UNITED STATES PATENT AND TRADEMARK OFFICE

APPLICATION NO.	FILING DATE	FIRST NAMED INVENTOR	ATTORNEY DOCKET NO.	CONFIRMATION NO.
10/812,041	03/29/2004	Frank M. Fago	MRD-116 (1495 US)	1450
27805	7590	03/17/2008		
THOMPSON HINE L.L.P. Intellectual Property Group P.O. BOX 8801 DAYTON, OH 45401-8801			EXAMINER CARPENTER, WILLIAM R	
			ART UNIT	PAPER NUMBER
			3767	
			MAIL DATE	DELIVERY MODE
			03/17/2008	PAPER

Office Action Summary	Application No. 10/812,041	Applicant(s) FAGO, FRANK M.	
	Examiner WILLIAM CARPENTER	Art Unit 3767

DETAILED ACTION

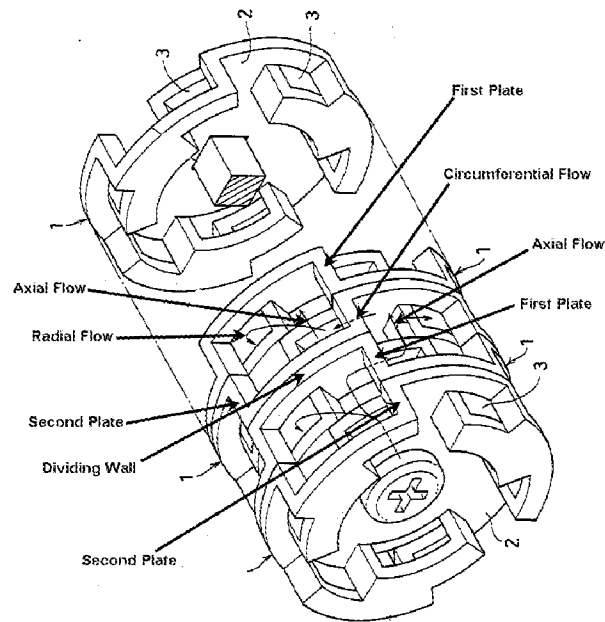
As regards to Claim 16, Kawasaki et al. discloses a pair of identical first plates (See attached figure) having a plurality of circumferential flow channels (2) and a plurality of radial flow channels (3) distributed between them.

As regards to Claim 17, Kawasaki et al. discloses a second plate (See attached figure) positioned between a pair of first plates separating the circumferential and radial flow channels on the upstream side of one first plate from the circumferential and radial flow channels on the downstream side of the other first plate.

As regards to Claim 18, Kawasaki et al. discloses the second plate to include an axial flow channel (See attached figure) which couples with the circumferential and radial flow channels of one of the first plates with the circumferential and radial flow channels of the other first plate. In the instant case the term "coupled" does not denote directly coupled and is instead assigned its ordinary dictionary definition of "to join for combined effect". The axial flow channels of the second plate allow for indirect connection of the radial and circumferential channels of the first plates through the radial and circumferential channels of the second plate.

As regards to Claim 23, Kawasaki et al. discloses that the suspension apparatus comprises a plurality of adjacent concentric circumferential flow channels to be coupled with one another via a plurality of radial flow channels (See attached figure).

As regards to Claim 24, Kawasaki et al. discloses that each of the pairs of first and second plates includes an axial flow channel to permit flow between adjacent sets of flow channels (See attached figure).

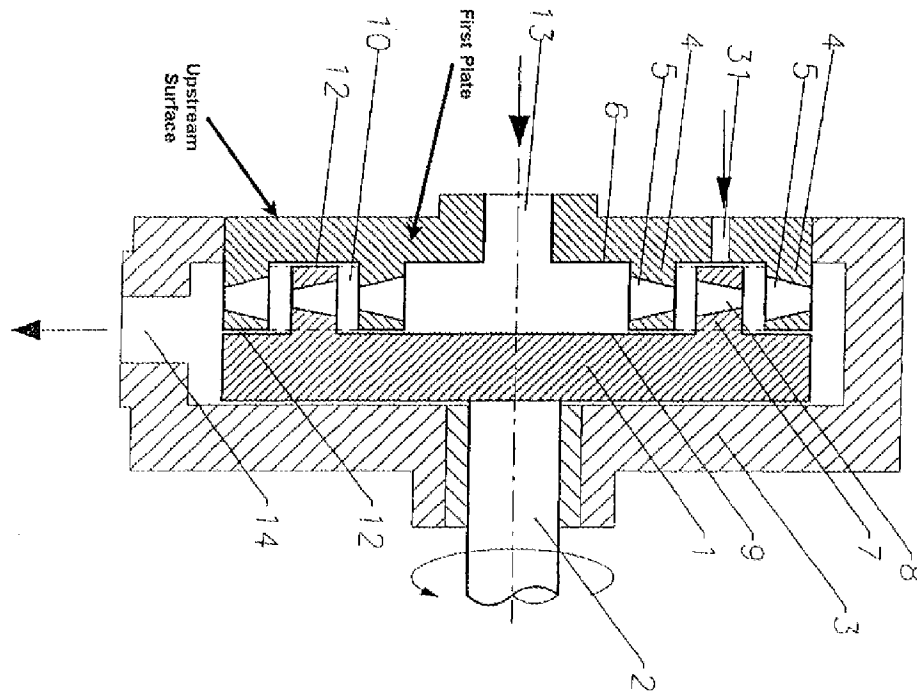
As regards to Claim 35, Kawasaki et al. discloses an apparatus for administering a suspendible agent in suspension including a suspendible agent, in the instant case concrete (Column 1, Lines 9-13), a suspension of cement, aggregate, water, chemical admixtures, and various other cementitious materials. Kawasaki et al. discloses a delivery container comprising the combination of a cement pump (Column 3, Lines 29-31) in combination with an external compartment comprising a feed pipe (4) having an exit port (See attached figure). Though not explicit, one would reasonably expect and appreciate that the cement pump as taught by Kawasaki et al. has access to a reservoir, either integrally formed with the pump or as an extension of the delivery container apparatus in a second external compartment. Kawasaki et al. further discloses a suspension apparatus disposed within the fluid path (1) including radial flow channels (3; See attached figure) and a plurality of circumferential flow channels (2; See attached figure) coupled in fluid communication by the radial flow channels. Furthermore, it is believed to further be inherent that the necessary reservoir for the device contains a propellant fluid in the form of unmixed cement. Claim 35 does not require that the suspendible agent and propellant fluid be of distinct compositions. The mechanism of action for the device of Kawaski et al. includes a cement pump which induces a fluid to flow through the feed pipe (4) and through the suspension apparatus (1). In this manner the unmixed fluid induced to flow by the cement pump acts as a propellant fluid, forcing a quantity of mixed fluid temporarily disposed within the suspension apparatus (the suspendible agent) to be ejected from the apparatus via the exit port.
